IREDELL COUNTY HEALTH DEPARTMENT

IMPROVEMENT PERMIT / AUTHORIZATION TO CONSTRUCT / OPERATION PERMIT / EXISTING SYSTEM INSPECTION

PERMIT# 141516 PIN# 4730557003 DATE 5-14-07

SUBDIVISION TWIN CREEKS BLOCK / SECTION II LOT 45 LOT AREA .157 SITE CLASS. PS DESIGN FLOW 480 L.T.A.R. .35

AS BUILT SKETCH

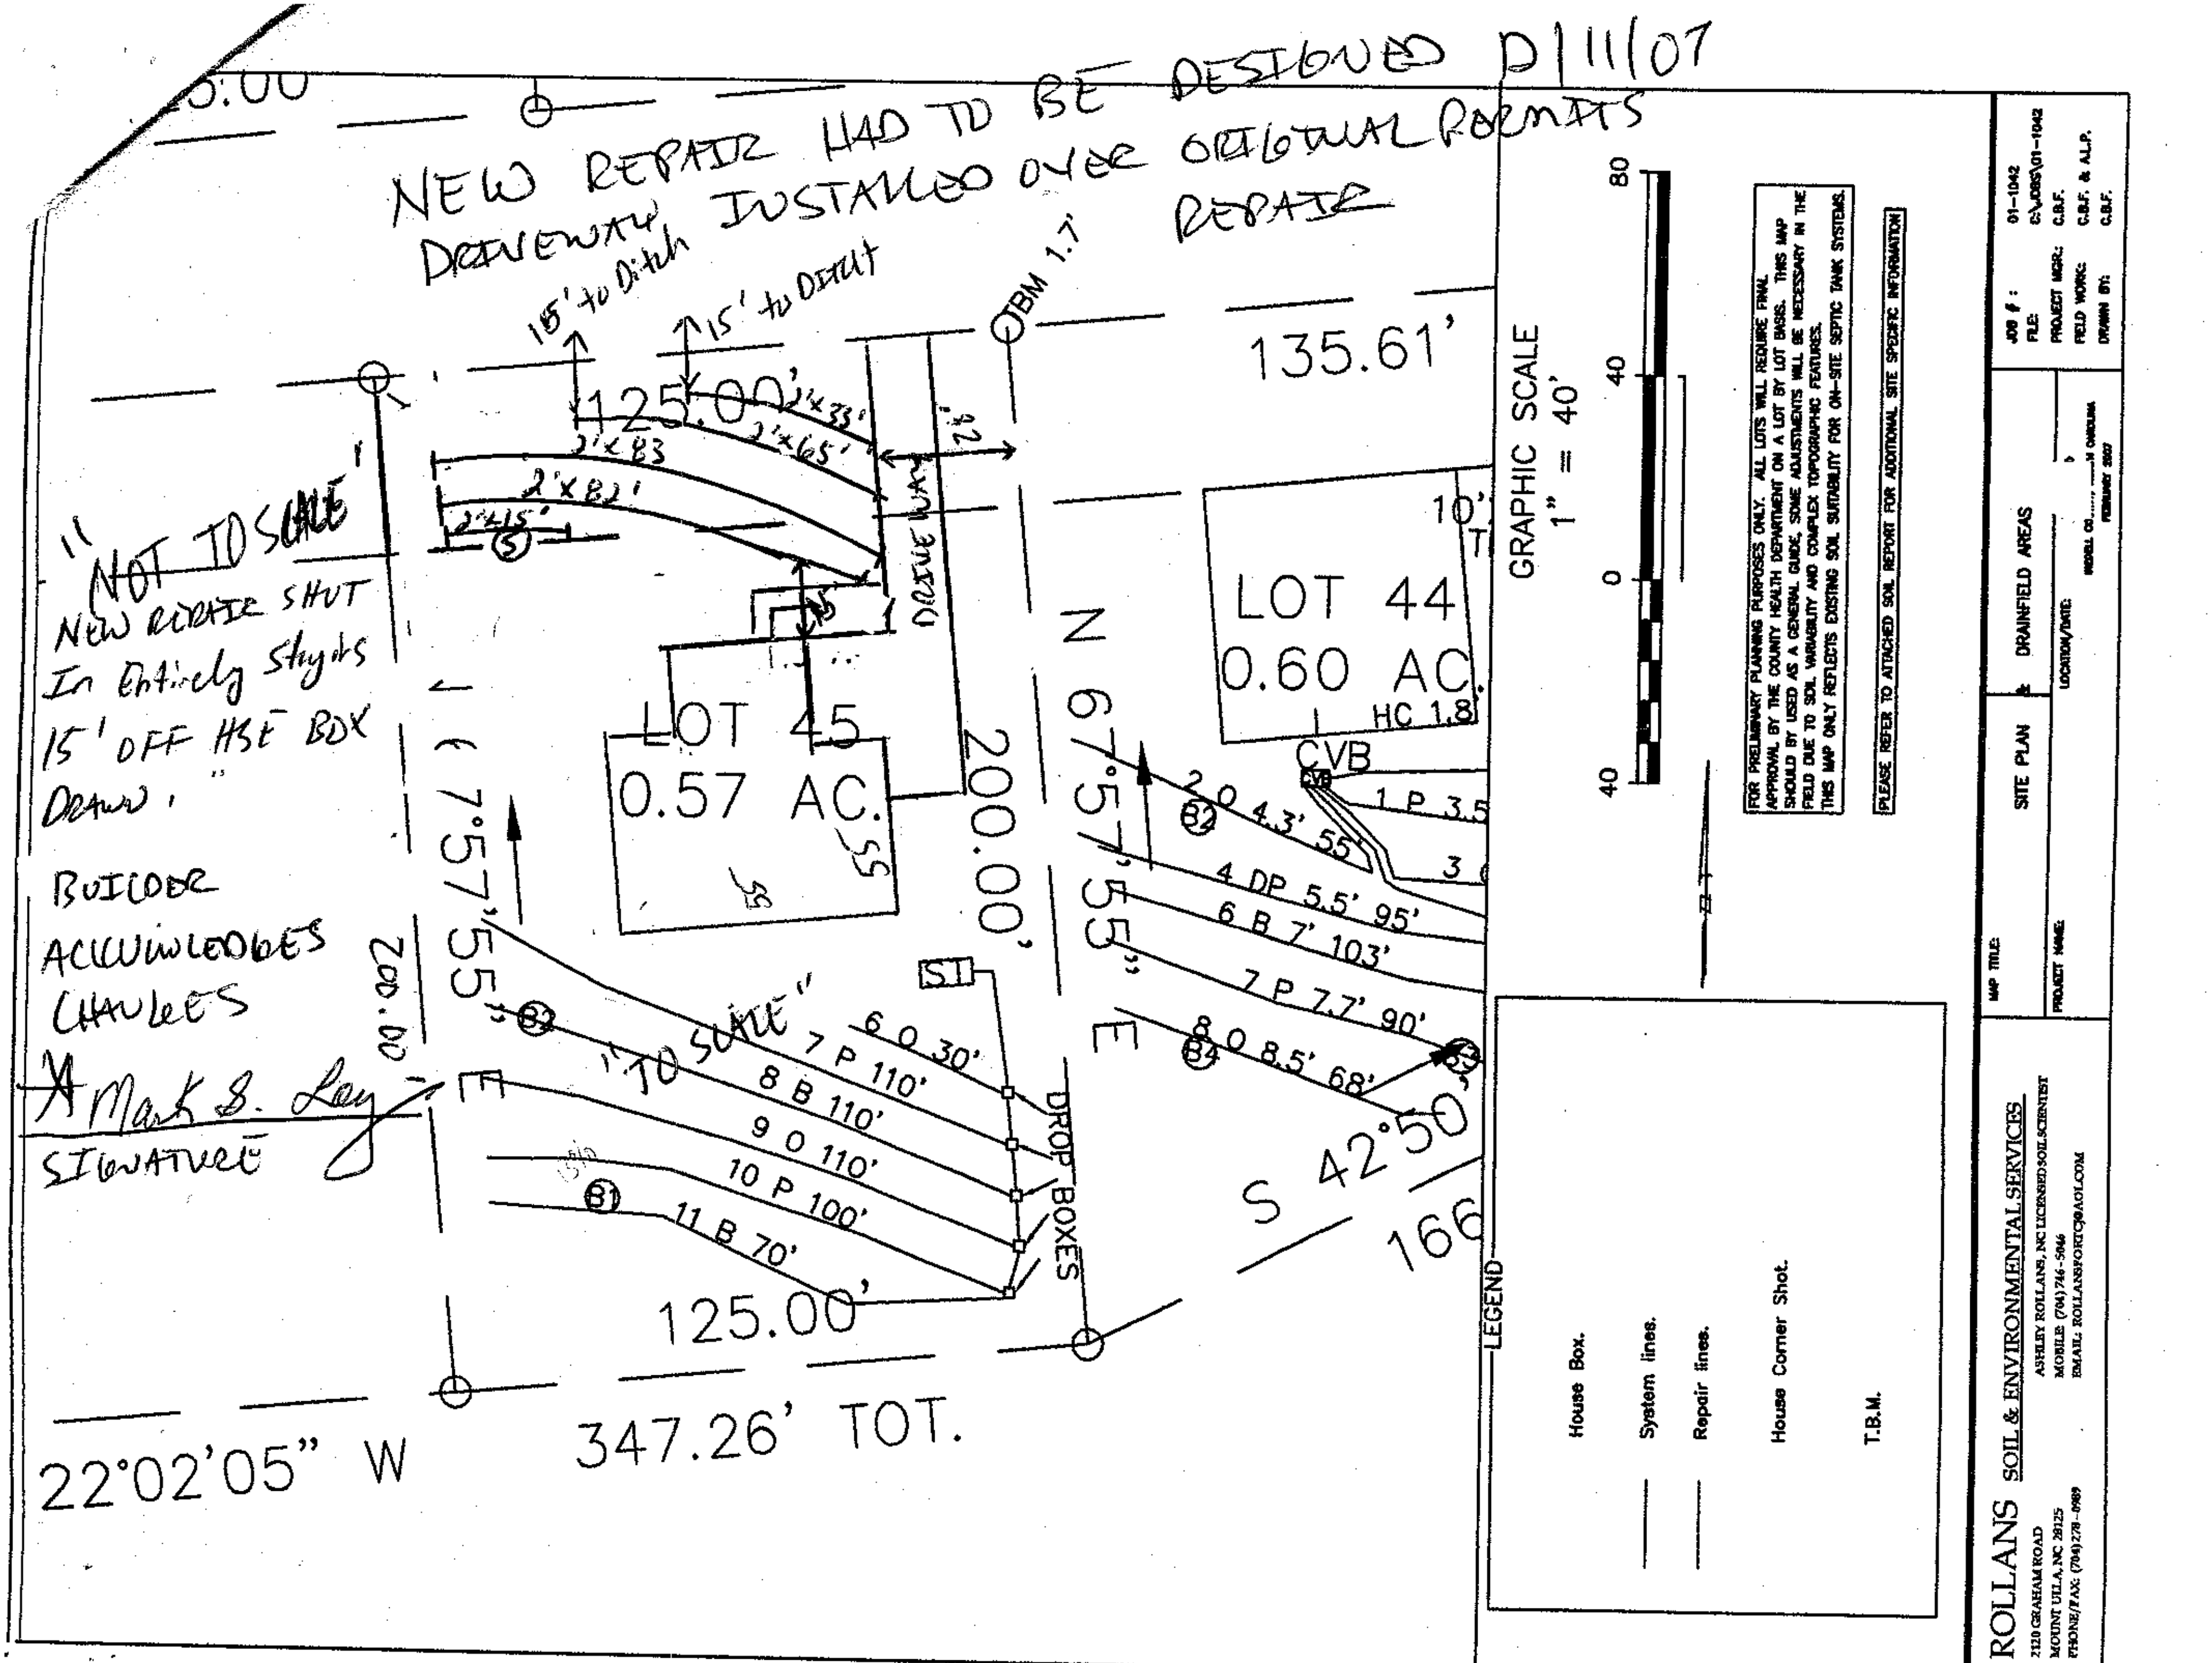
PAID NEW PERMIT FEE BECAUSE DURING FINAL DW SYSTEM REPAIR AREA WAS VIOLATED DUE TO DRIVEWAY. NEW REPAIR HAS TO BE REDESIGNED & IS ATTACHED IN THIS PERMIT PACKET 10-12-07

NEW REPAIR HAD TO BE DESIGNED D|11|07
NEW REPAIR HAD TO BE DESIGNED DRIVEWAY INSTALLED OVER ORIGINAL PERMITS REPAIR
15' to Ditch
15' to Ditch
TBM 1.7'
135.61'

125.00'
2'x33'
2'x83
2'x65'
2'x82'
2'x15'
DRIVEWAY
"NOT TO SCALE"
NEW REPAIR SHUT IN ENTIRELY Staying 15' OFF HSE BOX DRAWN.
BUILDER ACKNOWLEDGES CHANGES
SIGNATURE
LOT 45
